Project	IEEE 802.16 Broadband Wireless Access Working Group < http://ieee802.org/16 >	
Title	Sleep Mode Operations in MR Network for Centralized Scheduling Approach	
Date Submitted	2007-01-15	
Source(s)	<p>Shiao-Li Tsao, Fang-Ching Ren, I-Kang Fu, Wern-Ho Sheen National Chiao Tung University (NCTU) /Industrial Technology Research Institute (ITRI), Taiwan No. 195, Sec. 4, Chung Hsing Rd., Chutung, Hsinchu, Taiwan 310, R.O.C.</p> <p>Yuefeng Zhou; Sunil Vadgama Fujitsu Laboratories of Europe Ltd Hayes Park Central, Hayes End Road, Hayes, Middlesex, UB4 8FE, UK</p> <p>Keiichi Nakatsugawa Fujitsu Laboratories Ltd. Kamikodanaka 4-1-1, Kawasaki, 211-8588, Japan</p> <p>Yousuf Saifullah, Shashikant Maheshwari, Haihong Zheng Nokia 6000 Connection Drive, Irving, TX</p> <p>Kanchei (Ken) Loa, Yi-Hsueh Tsai, Shiann-Tsong Sheu, Hua-Chiang Yin, Chih-Chiang Hsieh, Yung- Ting Lee, Frank C.D. Tsai, Heng-Iang Hsu, Youn- Tai Lee, Institute for Information Industry, 8F., No. 218, Sec. 2, Dunhua S. Rd., Taipei City, Taiwan.</p>	<p>Voice:+886-3-5712121-54717 Fax:+886-3-5721490 E-mail: sltsao@cs.nctu.edu.tw, frank_ren@itri.org.tw</p> <p>Voice: +44 (0) 20 8573 4444 FAX: +44 (0) 20 8606 4539 Email: Yuefeng.z

Figure 1. MS sleep mode support for centralized scheduling

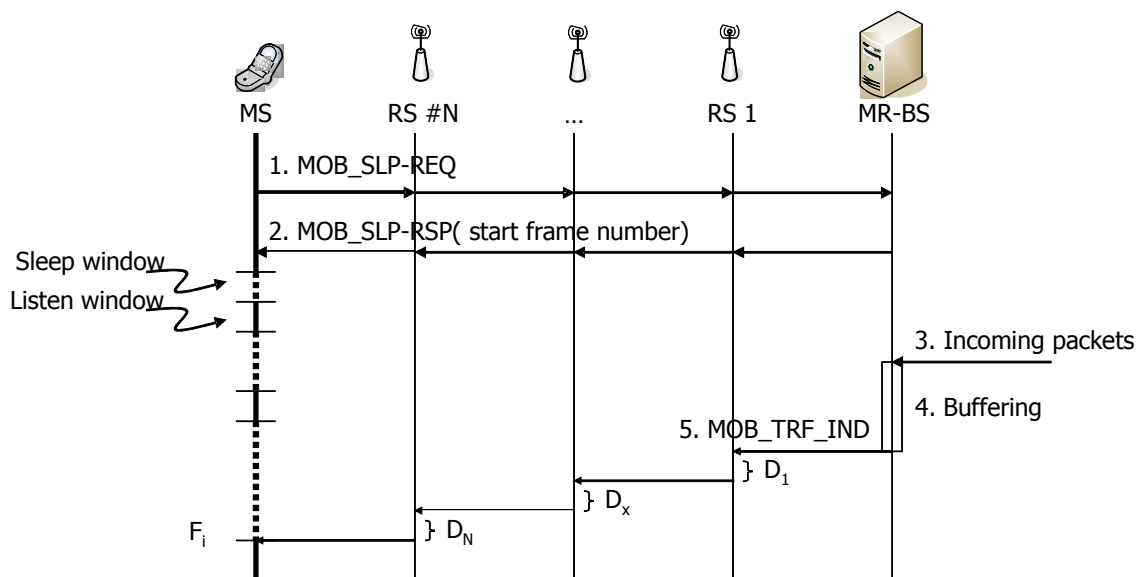
While sending MOB_TRF-IND to MSs for indicating incoming packets, MR-BS should take processing and scheduling delays introduced by RSs into the consideration. As shown in Fig. 1, MS enters Sleep mode by sending MOB_SLP-REQ and receiving MOB_SLP-RSP message with “Start Frame Number” parameter from MR-BS. While the MR-BS decides to send MOB_TRF-IND message to the MS which wakes up at frame F_i , the MOB_TRF-IND message should be sent from MR-BS $\sum_{i=1}^N D_i$ frames before the frame F_i . D_i is the processing and scheduling delay introduced by the i^{th} RS.

*Insert new subclause 6.3.21.7:*6.3.21.7 Relay support for MS sleep mode*Add the following words in the first paragraph in 6.3.21.7:*In MR networks, the sleep mode shall be centrally controlled by the MR-BS in the presence of centralized or distributed scheduling.*Insert new subclause 6.3.21.7.1:*6.3.21.7.1 MS sleep mode support for centralized scheduling approach*Add the following words in the first paragraph in 6.3.21.7.1:*For an MS attached to the MR-BS through an RS, MS sleep mode operates as defined in section 6.3.21. All MOB_SLP-REQ messages generated by MSs attached to an RS shall be relayed to the MR-BS. The MR-BS shall be responsible for generating MOB_SLP-RSP messages, which will be relayed by RSs, either in response to a MOB_SLP-REQ or unsolicited. The MR-BS shall take the additional relay delay into account while it forwards the packets through RS.
